CITY PLAN COMMISSION STAFF REPORT

Project Name
City Harvest

CD-CPC-2022-00174
Rezoning from district UR to district UR Development Plan

CITY HARVEST UR PLAN AND PRELIMINARY PLAT

1 LANDSCAPE PLAN - SOUTH
L900.A-UR = 10'-0"

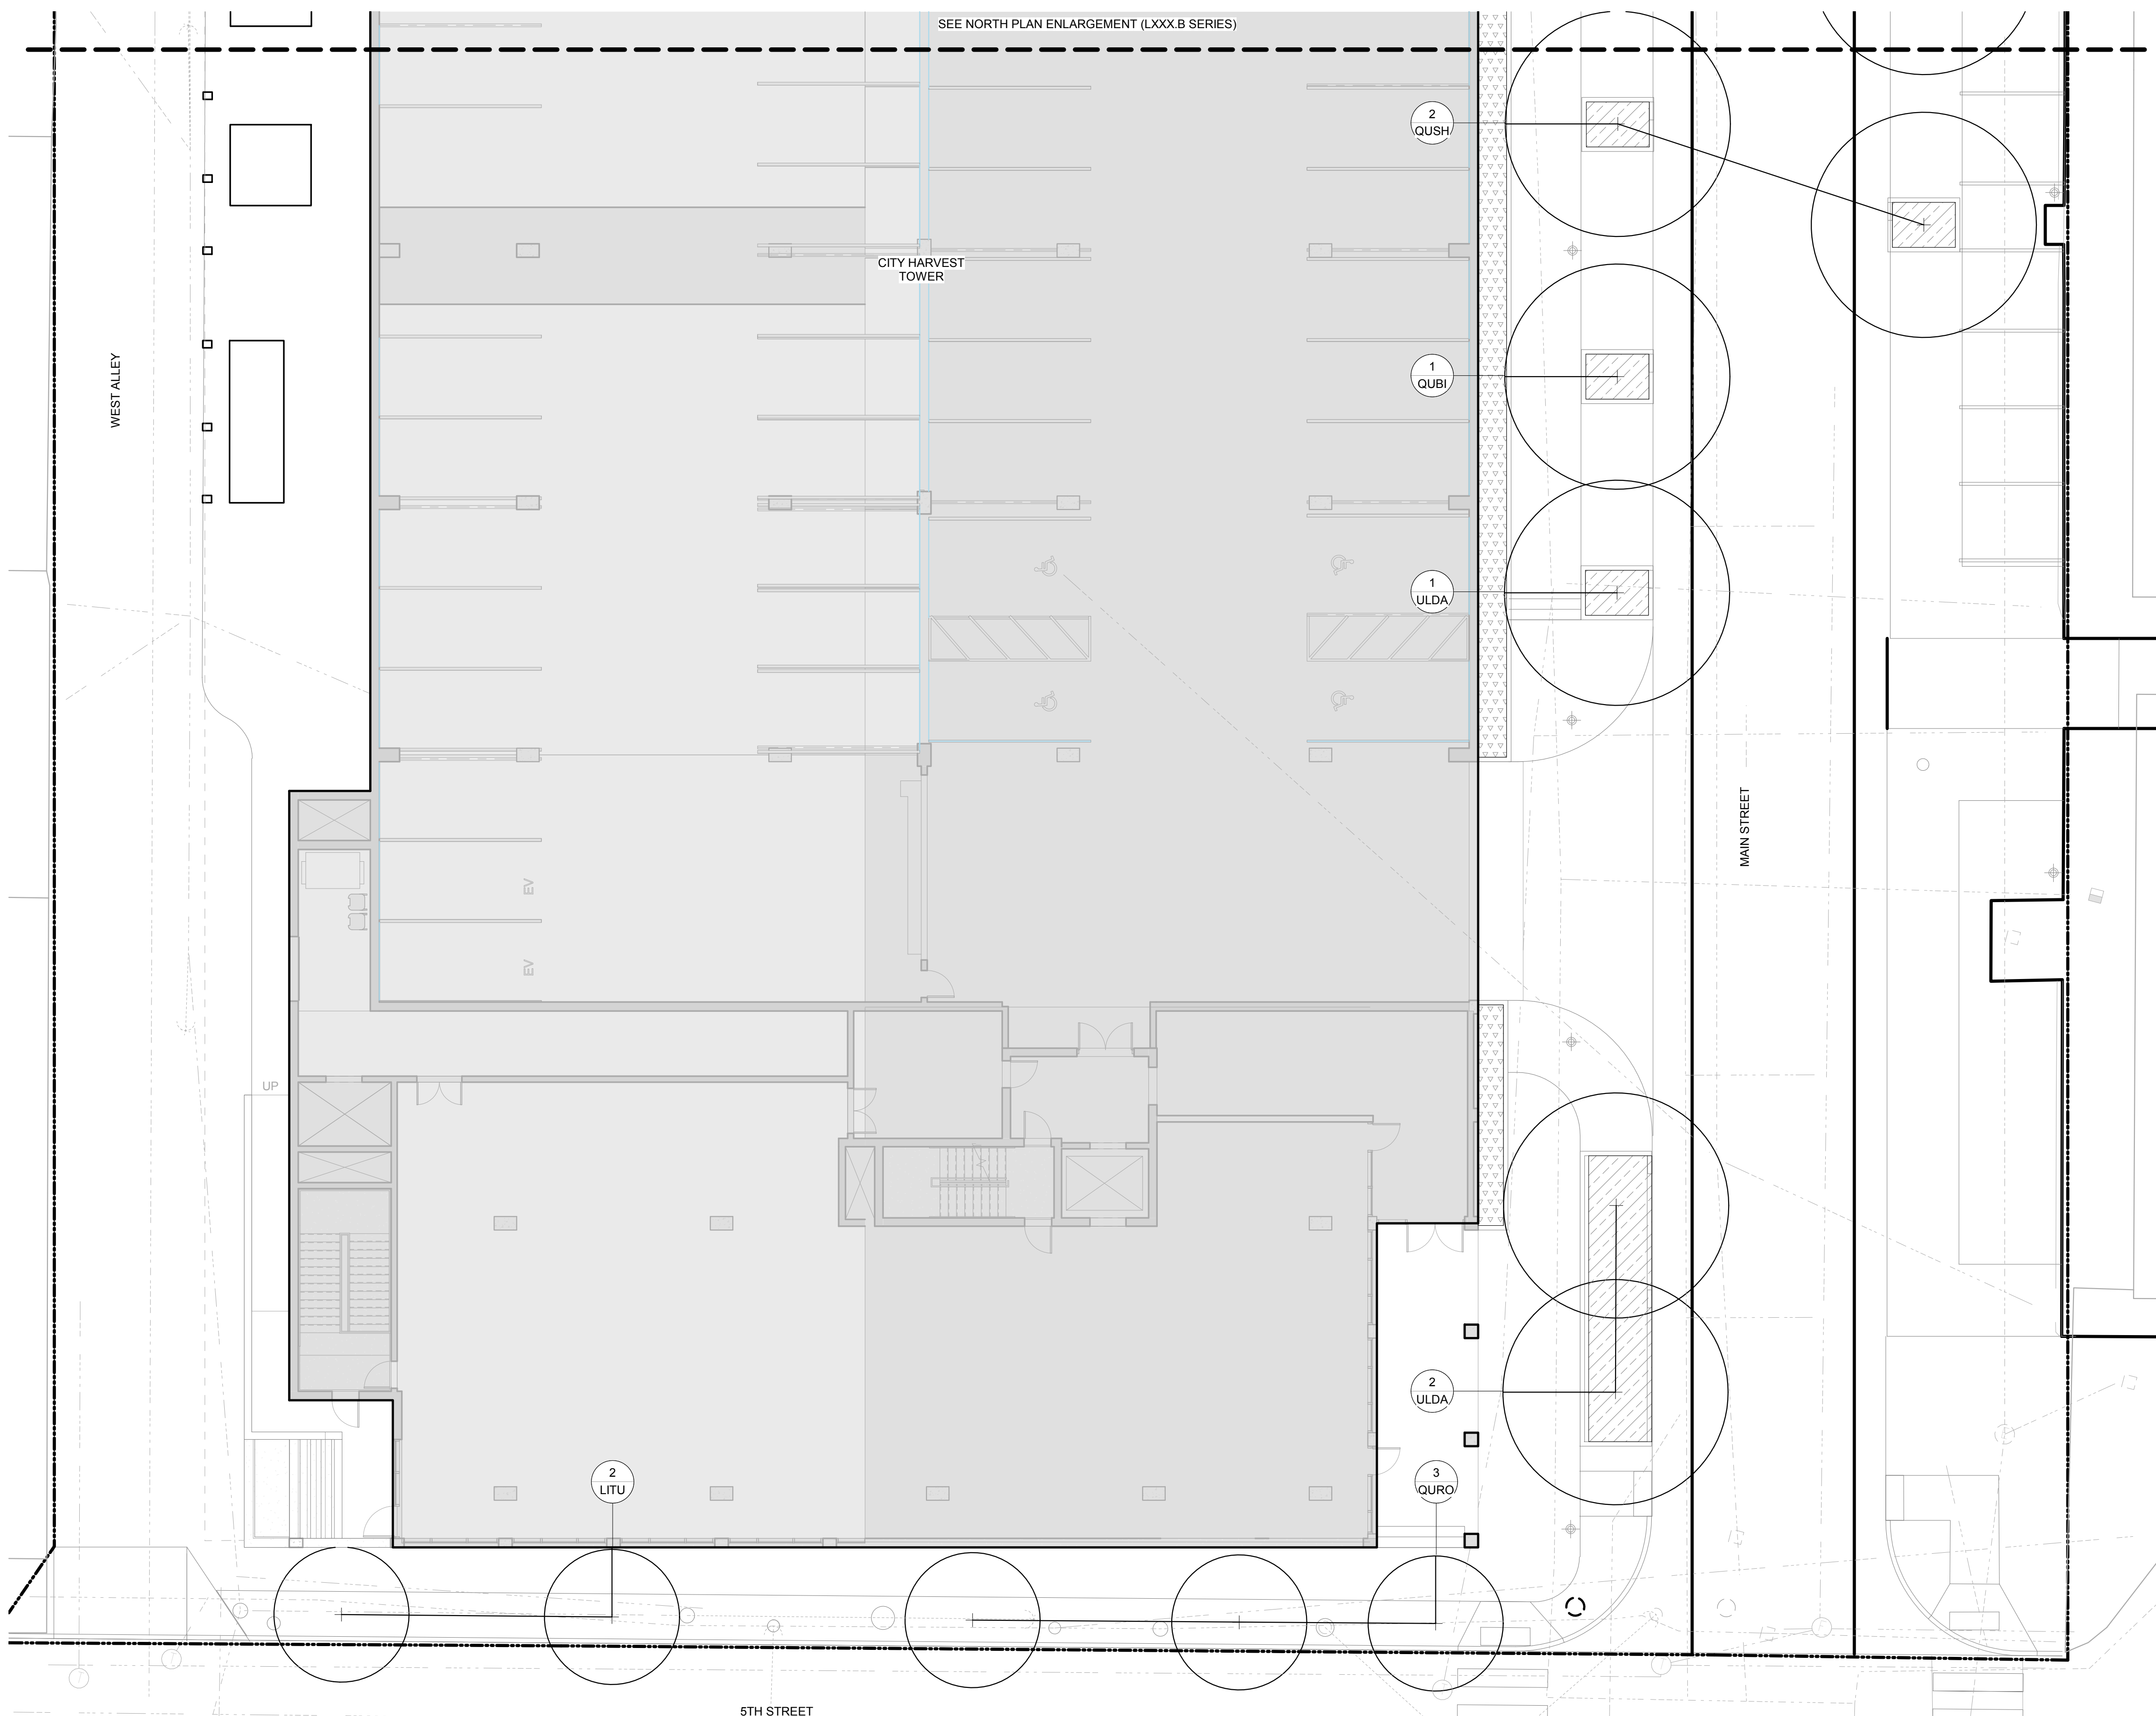
The Developer provided adequate landscaping along the North, East, and South side of the property, the Alley to the west does not allow for appropriate landscaping, the Developer will be required to work with staff to work on an appropriate alternative at the time of the UR Final Plan.

6. The developer shall submit a detailed list of landscaping materials with the submittal of the UR Final Plan. Staff is strongly encouraging the developer provide native vegetation throughout the site.
